A6980 P 1/1

► Change of Spur gear 51 and Driving flange Elimination of Pin 6 and Flat washer 30

▶ BHR242, BHR243, DHR242, DHR243, HR2300, HR2310T, HR2600, HR2601, HR2610, HR2610T, HR2611F, HR2611FT, HR2621, LXRH01, LXRH02, XRH01, XRH02

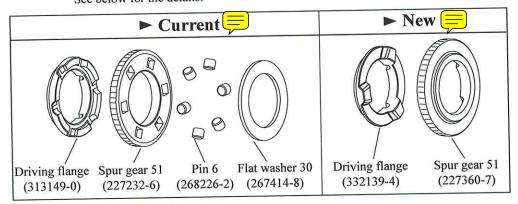
- Description To improve the durability of Spur gear 51:
 - Spur gear 51 and Driving flange have been changed.
 - Pin 6 (6 pcs.) and Flat washer 30 have been eliminated. See below for the details.

Item No.	Current part	Q'ty	I/C	New part	Q'ty	Note	
1		Spur gear 51 227232-6	1	No	Spur gear 51 227360-7	1	Interchangeable as a set	
2		Driving flange 313149-0	1	No	Driving flange 332139-4	1		
3		Flat washer 30 267414-8	1					
4		Pin 6 268226-2	6				↓ ↓
